Monitoring Well Conversion (OCD Comments)

EOG Resources Inc (OGRID 7377)
Ross Gulch 8 No.3
(SWD-1311)
Action ID 254154

From: [Harris, Anthony, EMNRD](#)
To: [Jordan Kessler](#); [Goetze, Phillip, EMNRD](#)
Cc: [Wrinkle, Justin, EMNRD](#); [Gebremichael, Million, EMNRD](#); [Patrick Padilla](#); [Tyler Burns](#)
Subject: RE: [EXTERNAL] Ross Gulch monitoring well conversion request
Date: Monday, February 19, 2024 2:34:00 PM
Attachments: [image001.png](#)
[image002.png](#)
[image005.png](#)
[image003.png](#)

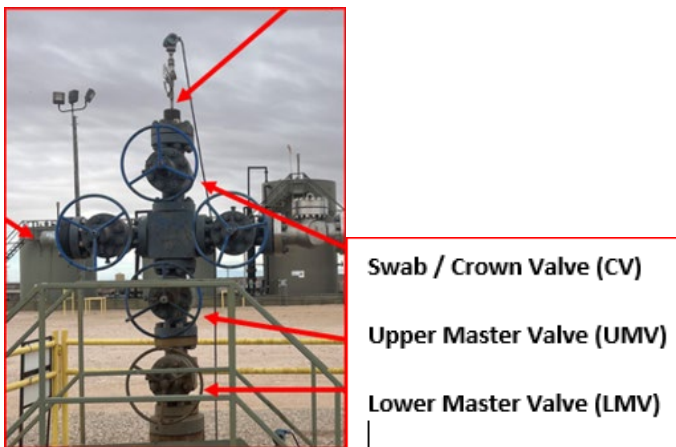
We have some questions regarding the proposed running procedure for the gauge and the dual packoff assembly. To avoid any confusion, I wish to clarify the following terminology

- **Swab/Crown Valve: (CV)** Uppermost valve in the image below
- **Flow Cross:** 4-way Block below the crown valve with side outlets for wing & kill valves
- **Upper Master Valve: (UMV)** Manual valve below the flow cross
- **Lower Master Valve: (LMV)** Manual Valve below the Upper valve (ie. lowermost valve in below image)

I have pasted a copy of your procedure below, and inserted questions / items to clarify in **red text**.

1. MIRU Modified Wireline Unit. Prep to run real-time bottom hole pressure gauge (RT BHPG) and cable.
2. NU 5K BOP and new swap valve packer. Function test all valves and pressure test connections before proceeding.
 - Please provide a stack-up drawing to illustrate the pressure control equipment utilized for deployment and retrieval of the gauge.
 - It is assumed both packoffs will be pre-installed below the BOP during deployment and/or retrieval? Please confirm
 - What is the estimated weight of the BOP's and Pressure control

- equipment that will be transferred to the packoff assemblies?
- Please confirm the packoffs are designed to handle the compressive and shear loads transmitted via the BOP and Pressure control equipment during rigup, pressure testing, deployment and retrieval.

- Prior to installing the BOP, will the gauge and cable already be deployed below the crown valve?
 - Note: The gauge is ~ 14" long and OD=0.75". Since the Packoff ID= 0.25", the only option appears to deploy the gauge below the crown valve (ie. hung across the flow cross and UMV) while rigging up the BOP? Please confirm

- Barrier protocol - Please confirm which valves will be open / closed during rigup and pressure testing of the BOP and lubricator
3. TIH 0.75" OD BHPG and 0.25" OD cabling. Stop at 4,020'.

- How is depth control achieved to ensure the gauge is placed at 4020 ft?
 4. Secure cabling. NU double swap packer. ND Lubricator, RD Wireline Unit.
 - Is this different from the swab valve packer that was installed in Step 2?

- How is the packer installed when the BOP and lubricator are already rigged up on the well?
 - No mention of rigging down BOP. Please confirm when BOP will be removed. Presumably after pressure seal is confirmed in Step 5?

5. Check for leaks and increase packing fluid as needed to confirm pressure seal.
 - How is pressure seal confirmed? Via inflow test? How do you confirm if there is no pressure on the wellhead at the time?

- Are there any other pressure tests planned to confirm the packoff seal integrity?
 6. Remove wheels from lower and upper master valves and place near wellhead. Wheels are removed to avoid accidental cutting of the wire hanging in the well.

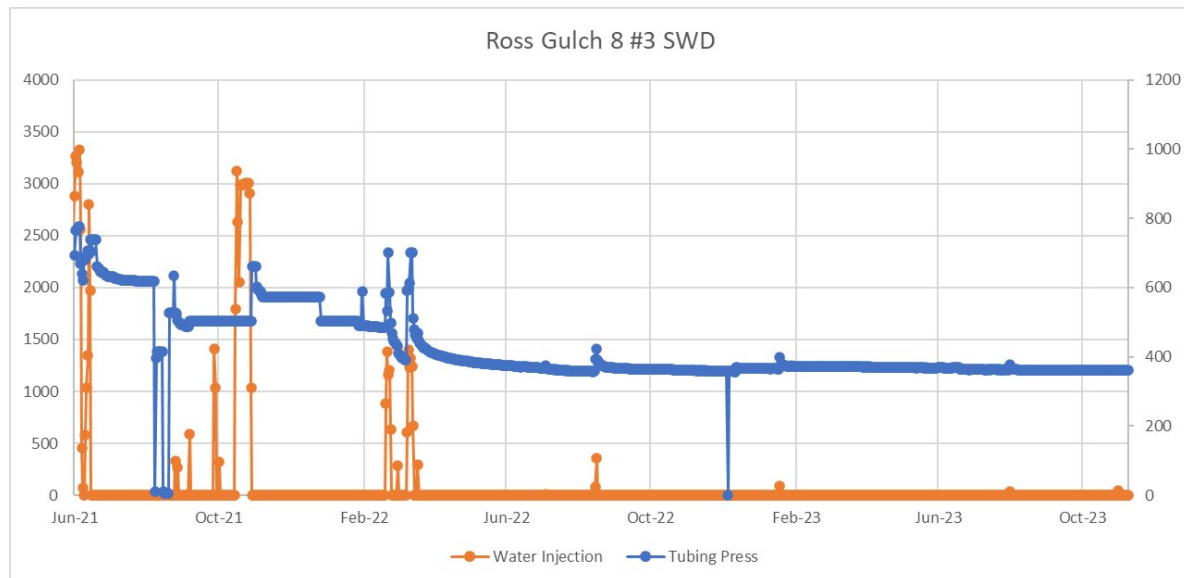
5. Please provide details on well inspection frequency (to verify packoff is not leaking) and well control protocol for this well. This should include an overview of the barrier(s) (closed and closeable) available for well control, a procedure to follow if a leak is observed in the packoff / stuffing box and a procedure if the packoff has to be replaced with positive pressure on the well (noting that the master valve cannot be closed below the packoff if there is a cable across the valve).

- We will have continuous monitoring via the camera to our control room.
- We will visually inspect daily on-site.
- In the event of a well control event, we will pump a kill fluid into the wellbore via the wing valve connection.
- In the event of a single failed packoff, we will kill the well and install a new dual packoff.
